PROJECT MINUTES

Project:	New Peebles Elementary School	Project No.:	15041
Prepared by:	Joel Seeley	Meeting Date:	4/27/2017
Re:	School Building Committee Meeting	Meeting No:	38
Location:	Veterans Memorial Community Center	Time:	6:30pm
Distribution:	School Building Committee Members, Attendees (MF)

Peebles Elementary School Design Update

Phasing Update

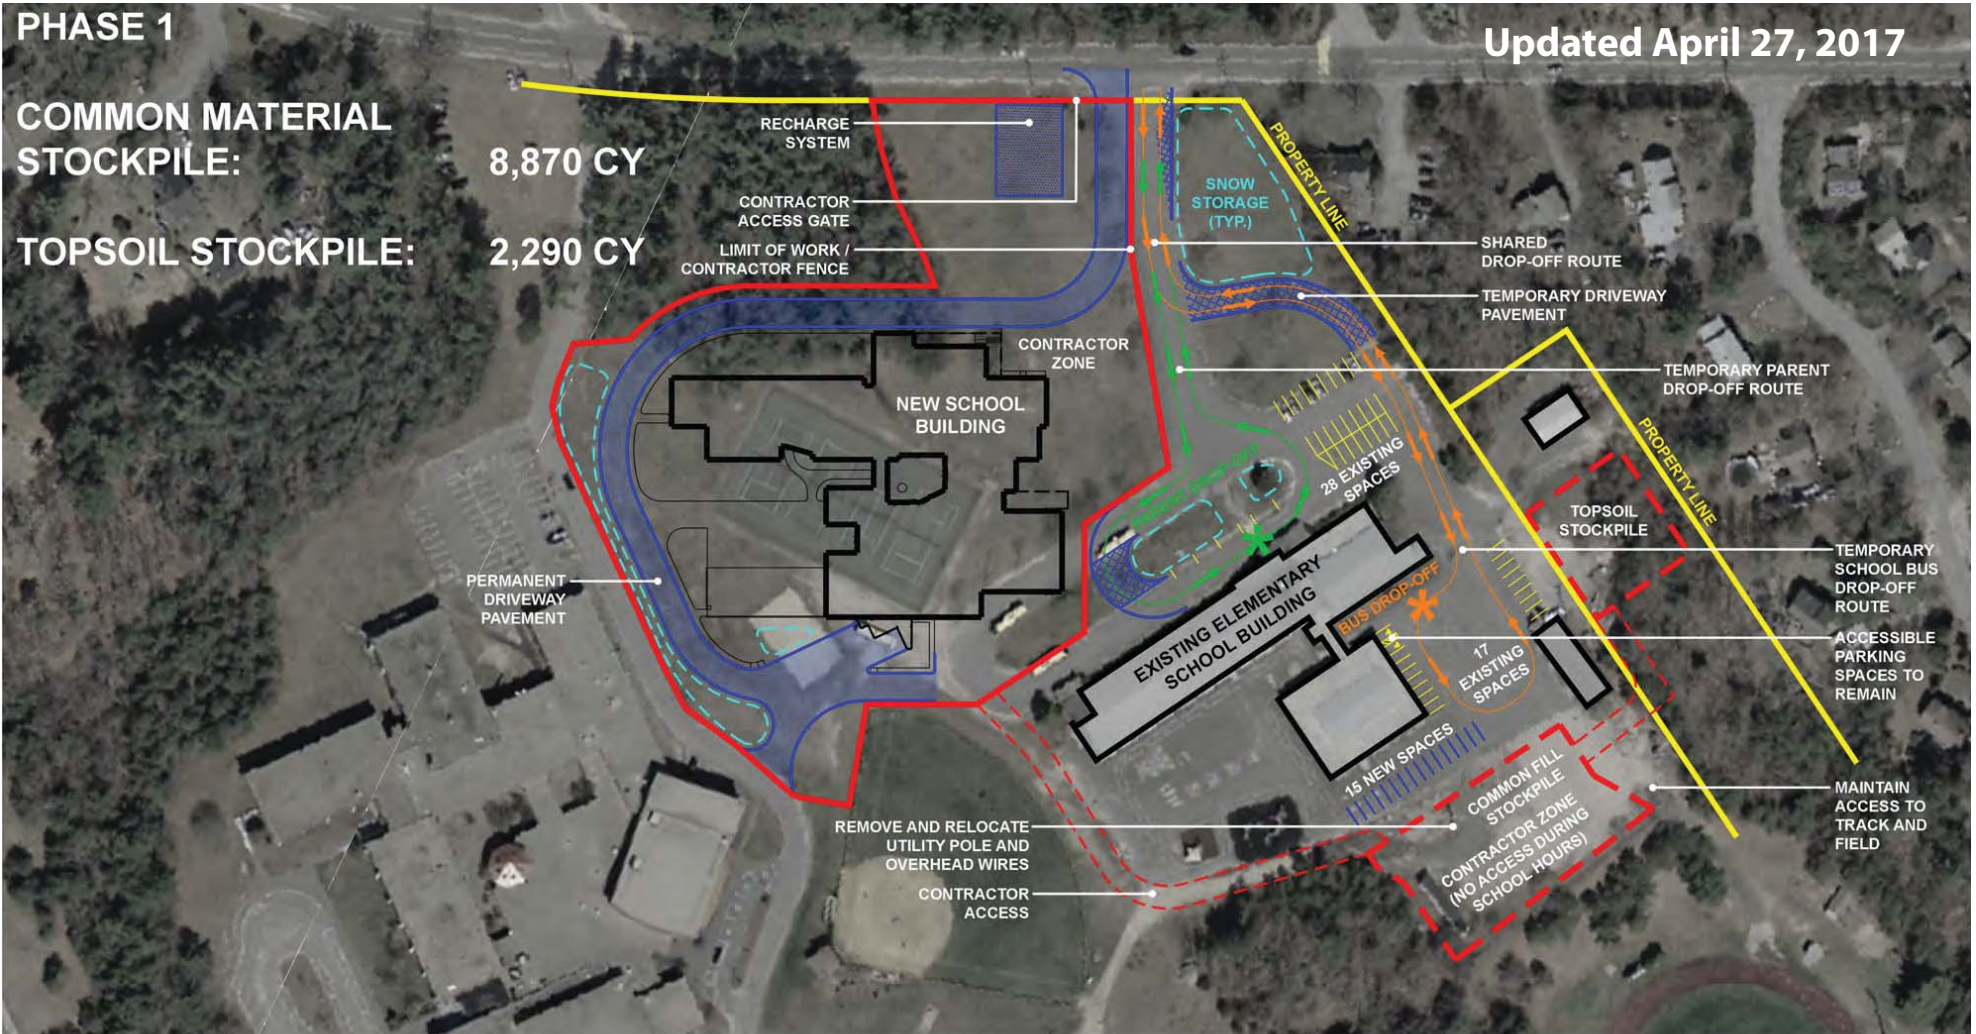
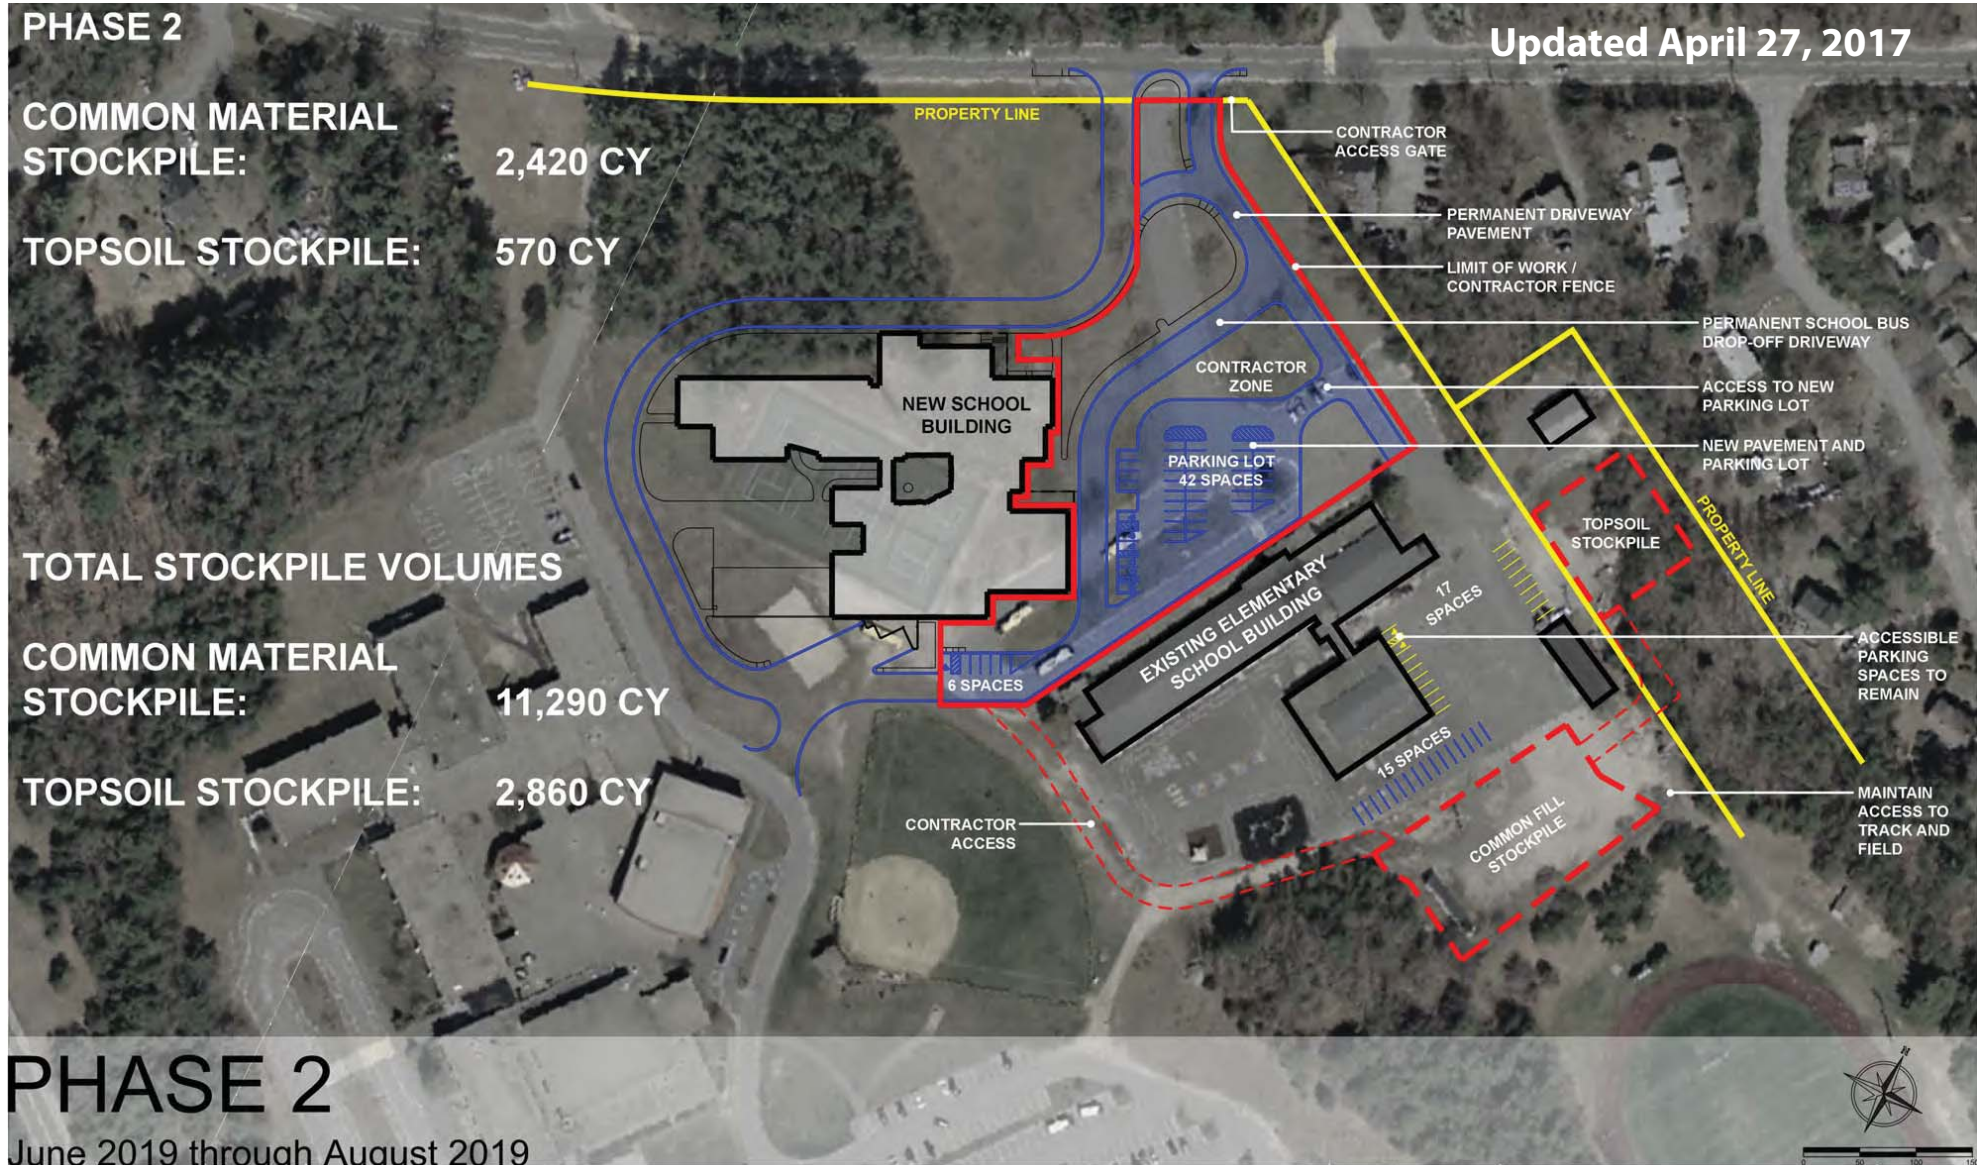
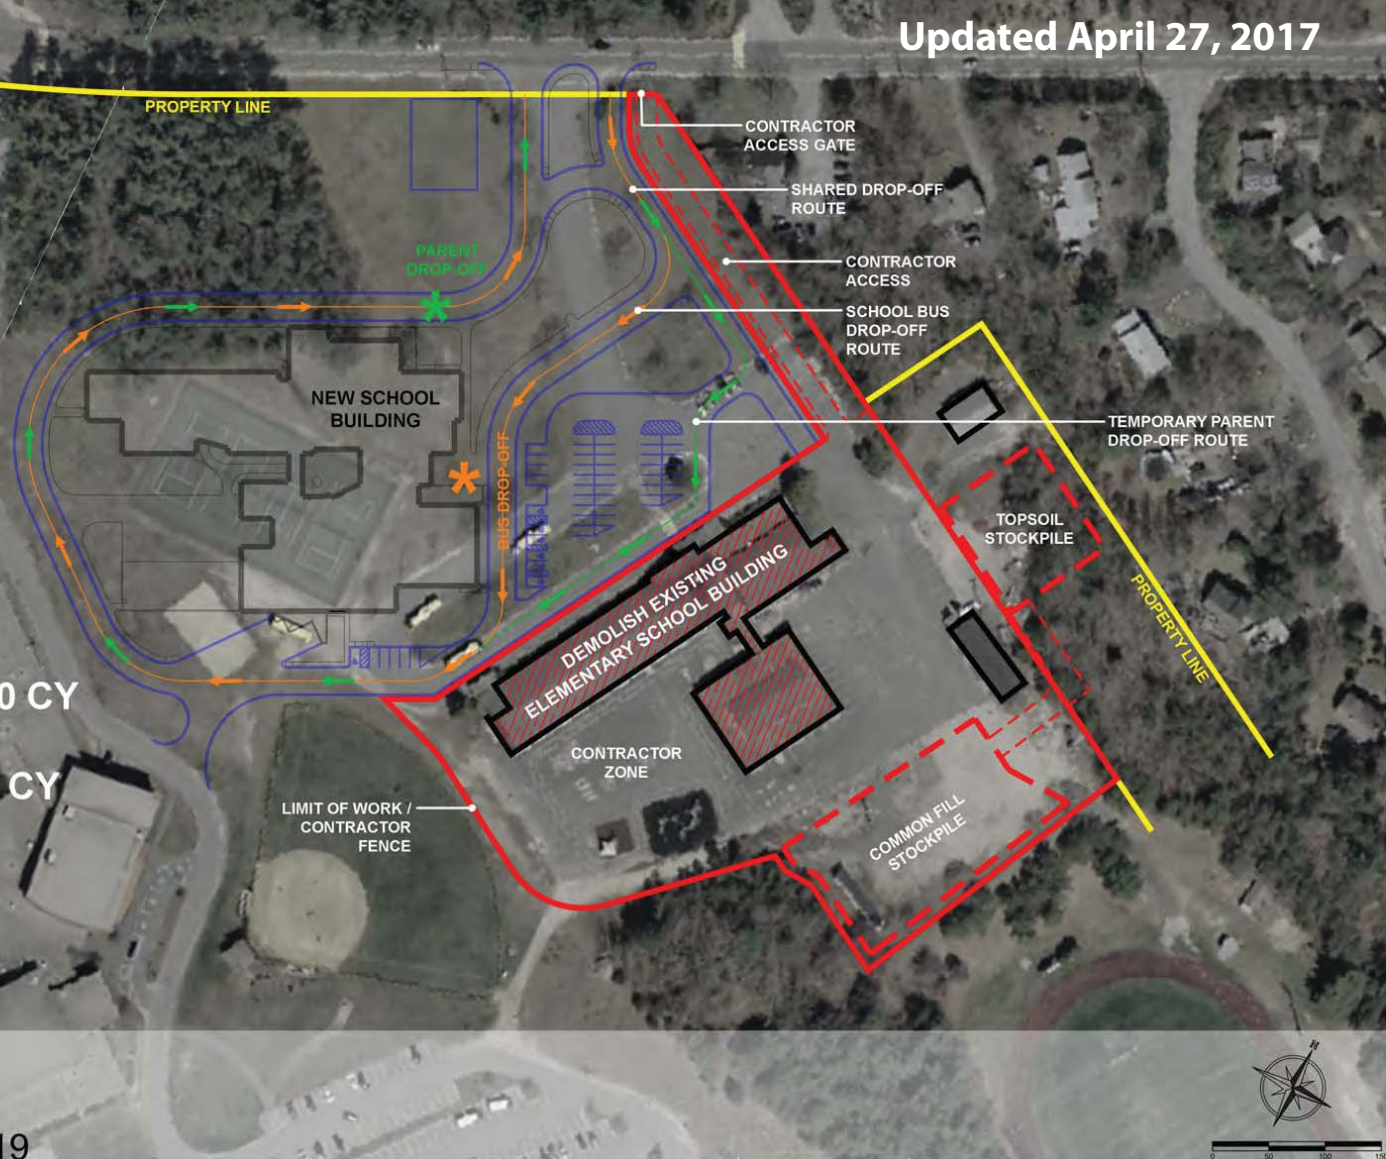
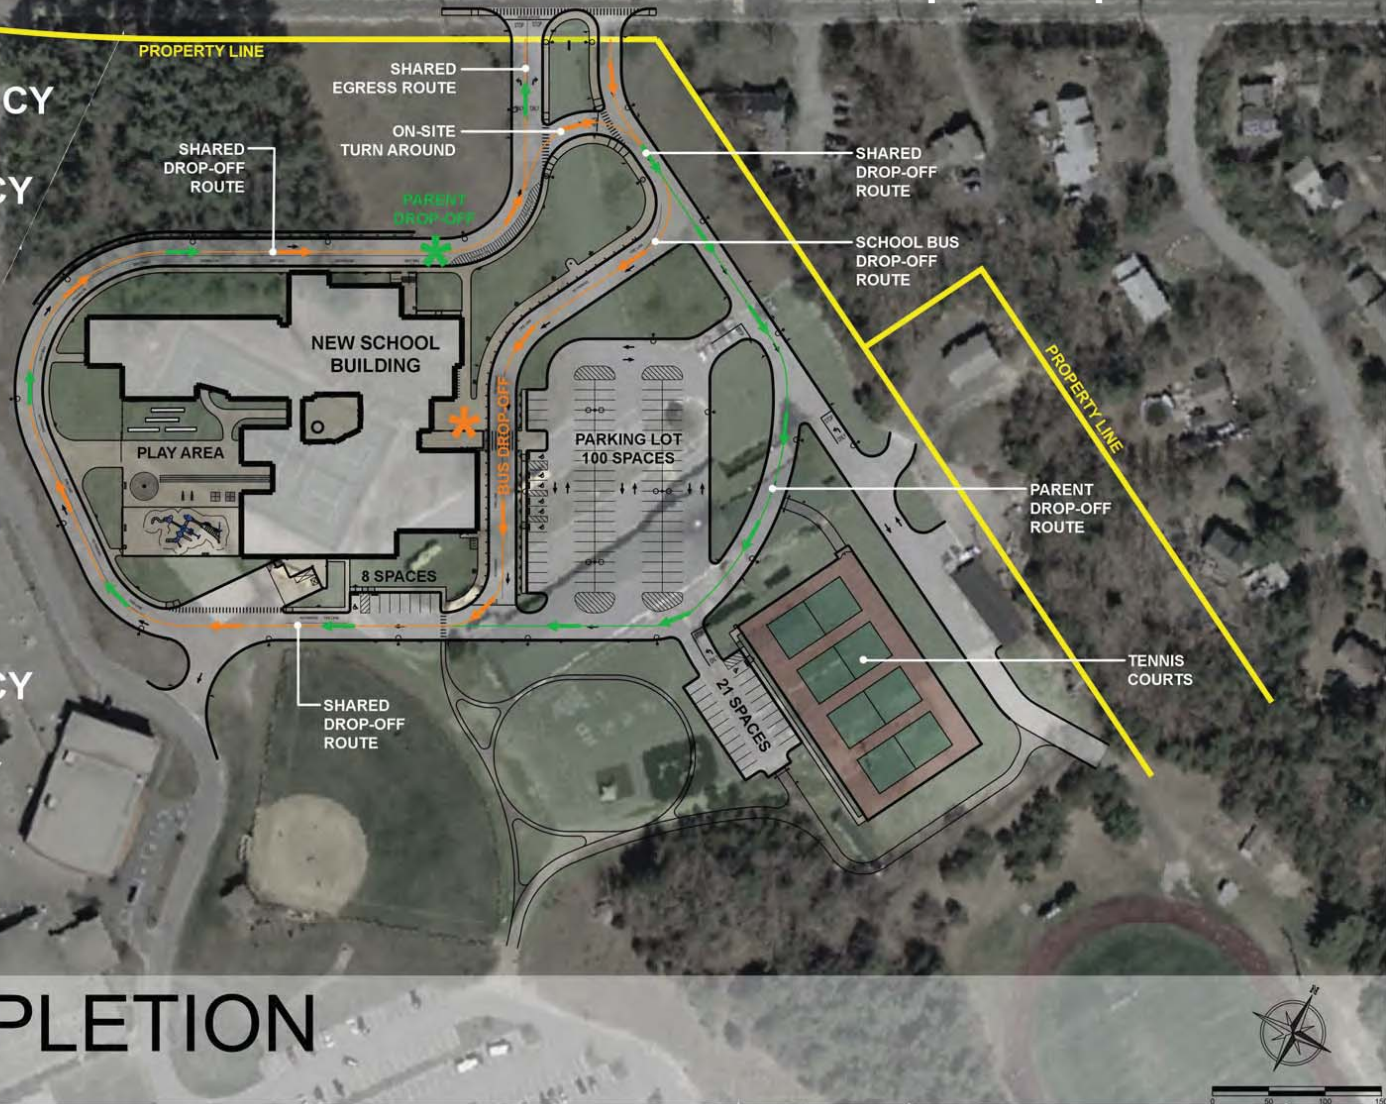
38.17	K. Kovacs	<p>K. Kovacs presented the updated Construction Phasing Diagrams, attached. K. Kovacs indicated that a location for the Topsoil Stockpile has been determined within the Phase 3 construction area. The approximate 12 parking space shortfall for teachers and staff during Phase 3 will be located in the adjacent high school parking lot operationally, not part of the construction work.</p> <p>Committee Discussion:</p> <ol style="list-style-type: none"> 1. K. Kovacs indicated the emergency and ADA access to the football field during construction will be from the Middle School. K. Kovacs will review with the Police and Fire Department.

Mechanical Diagram Roof

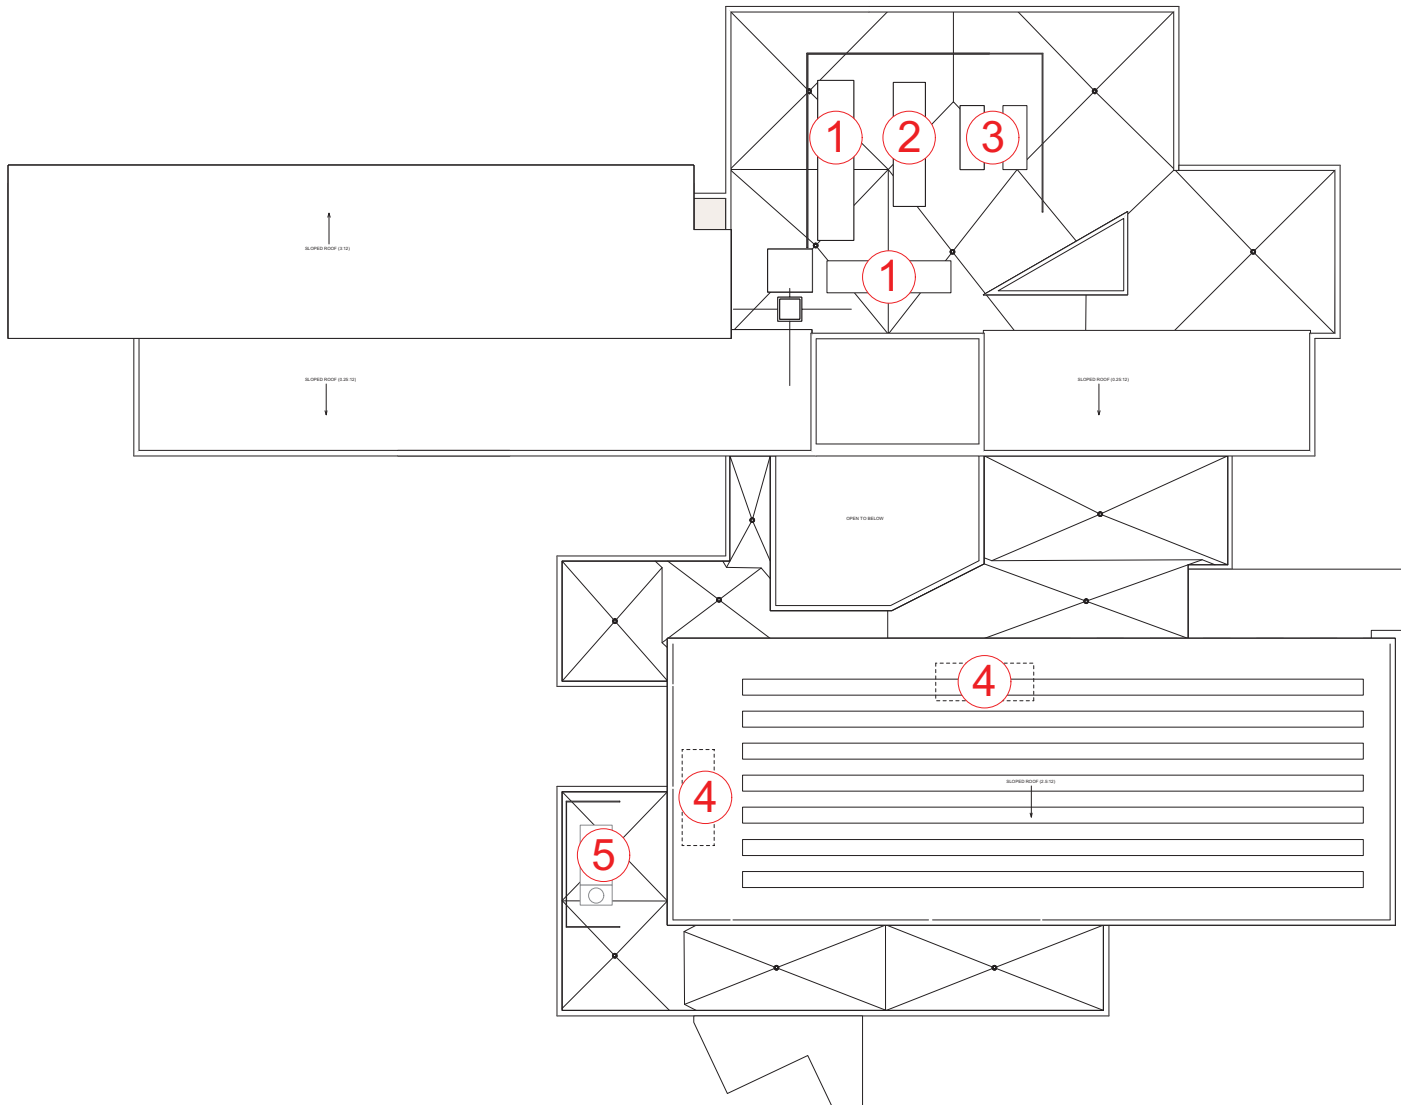
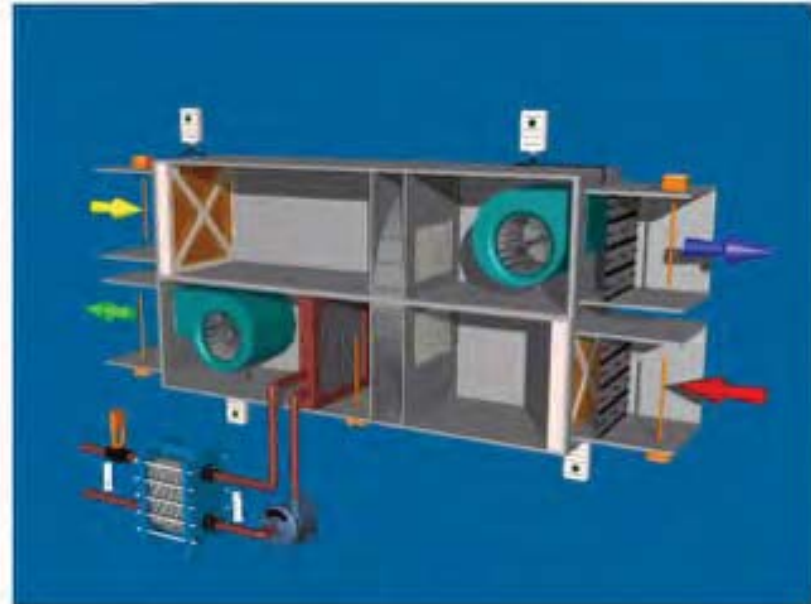
4. In the Kitchen MAU-1 system, the plans for the control sequence indicate that the MAU and KEF will return to the normal mode of operation. I am not sure if the fire dept. allows that. Seems that an automatic restart would be allowed by the sequence without determining the cause of high CO with this wording. CO should probably be a manual reset.

6. Are the ATC/BMS systems on a separate vLAN so that they can be accessed via internet and not compromise any firewalls in the LAN? Hackers have invaded networks via HVAC networks that are connected to the LAN. With this in mind, it is still very important to be able to access the BMS from off-site.

7. My experience has been that the BMS server being provided with emergency power is also best served with an Uninterruptible Power Supply to avoid the loss of power experienced between loss of normal power and connection of the emergency power which can take approximately 10 seconds. Although not critical it can avoid issues with the BMS.

GGD: Within the Electrical scope of work the CO detectors are provided and are activated when levels within the Kitchen exceed the recommended limit, once this threshold is achieved the kitchen gas valve will close and a supervisory alarm will be generated. The Kitchen exhaust fan remains on to remove any residual CO. The Make Up Air unit is shut down during this activation. Currently we have the Make Up Air unit restarting automatically once CO levels reduce below the threshold with an alarm being activated at the BMS indicating high CO levels. We will modify the sequence to have the MAU provided with a manual restart and we will confirm with the local Fire Department to ensure this sequence is acceptable.

GGD: VLAN's will be utilized for the Building Management System.

GGD: All controls will be powered from emergency circuits therefore power failures will not affect the system. Also field controllers will be provided with non-volatile memory and battery back-up will be provided on the main head end controller.
